# **Oyster Creek License Renewal Presentation to ACRS**

February 1, 2007

# Drywell Shell Corrosion

Issues from January 18, 2007

### Impact of Modified Capacity Reduction Factor on the Effective Factor of Safety with Uniform Sand Bed Thickness

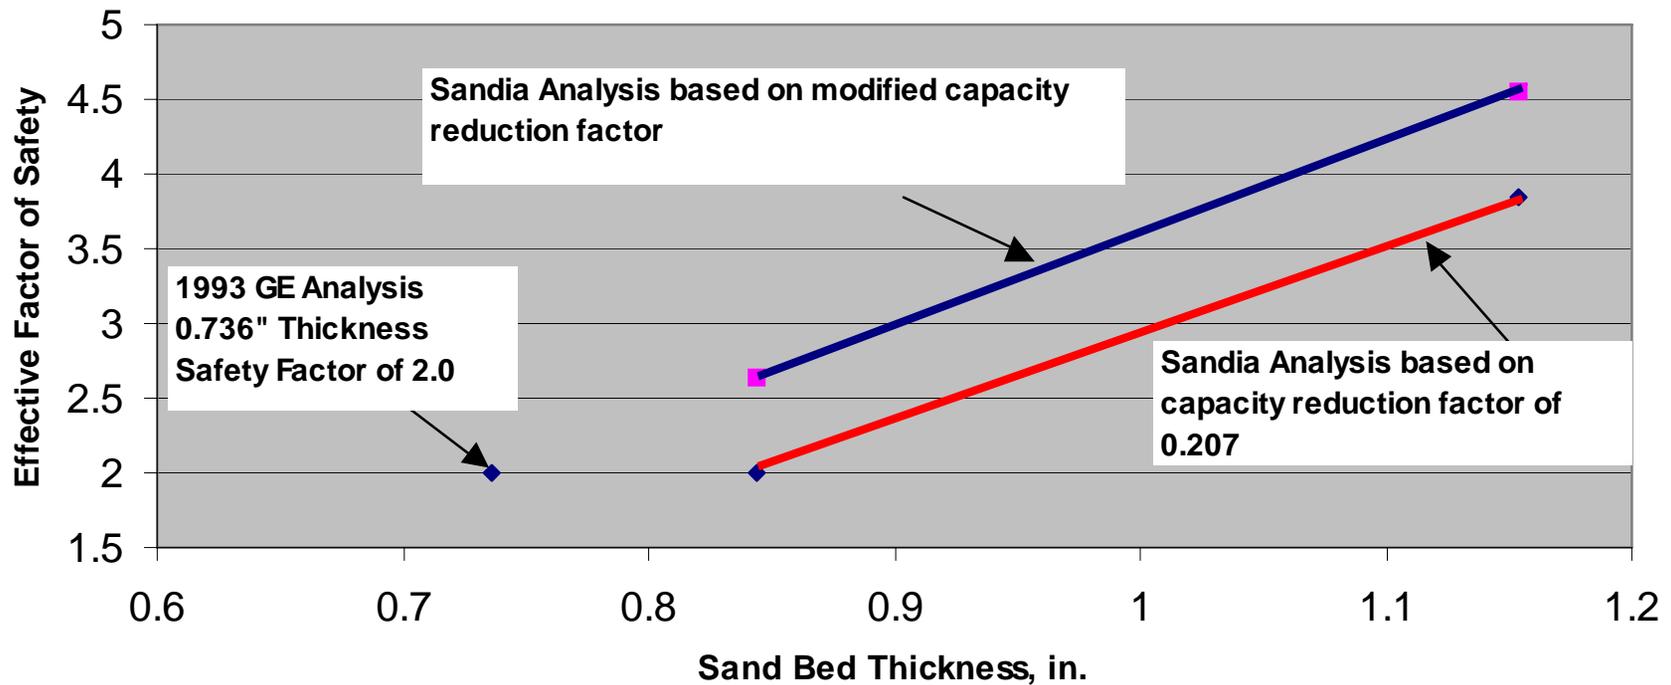
The GE analysis and Sandia analysis are different. A key difference is that the GE analysis increased the capacity reduction factor for the refueling load combination case when there is no internal pressure present. Is this acceptable?

The increased capacity reduction factor used in the GE analysis is acceptable.

- Capacity Reduction Factor,  $\alpha_i$ , was increased to account for the effect of a coexisting orthogonal tensile stress
  - The increase was based upon tests conducted on cylinders
  - Tests conducted on spherical segments concluded that the modified  $\alpha_i$  based on cylinder test results is conservative

Note: Re-drawn from Sandia Report SAND2007-0055 page 79  
(Red Curve)

## LOWER DRYWELL- SANDBED, TRENCH & SUMP

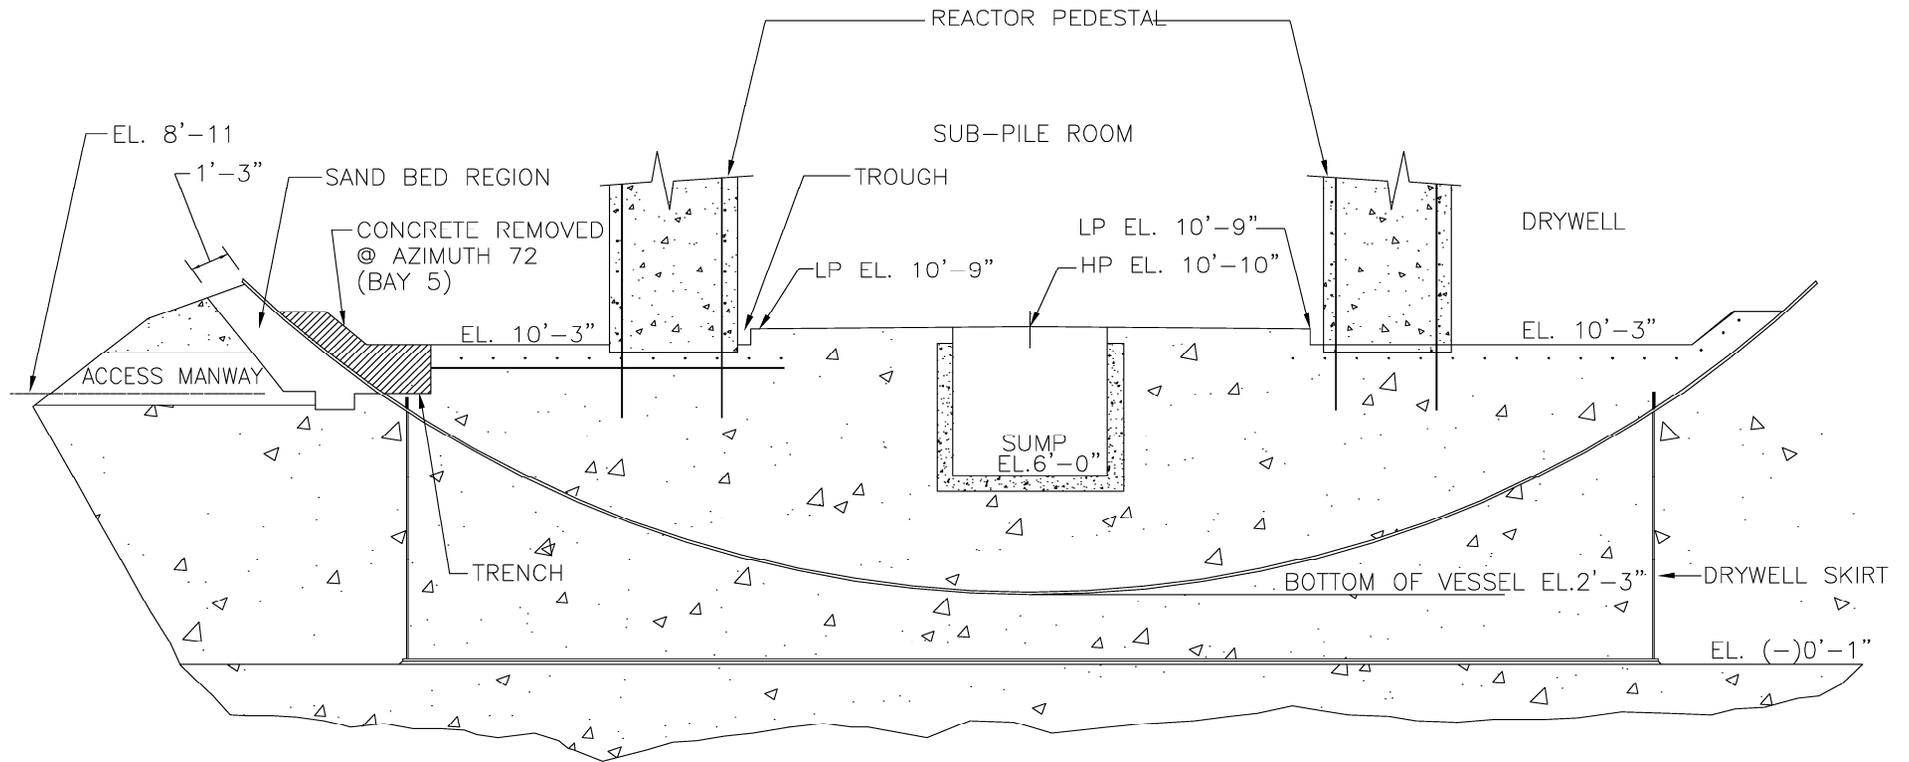
The trenches in the drywell floor should not be restored to the design configuration until sufficient monitoring is completed to verify corrective actions to eliminate water on the interior drywell shell have been effective.

The trenches in the drywell interior floor

- Inspect during refueling outages for water.
- Visual/UT exams of shell within trenches.
- After confirming in 2 consecutive refueling outages there is no water in the trenches, restore the trenches to their original design condition.
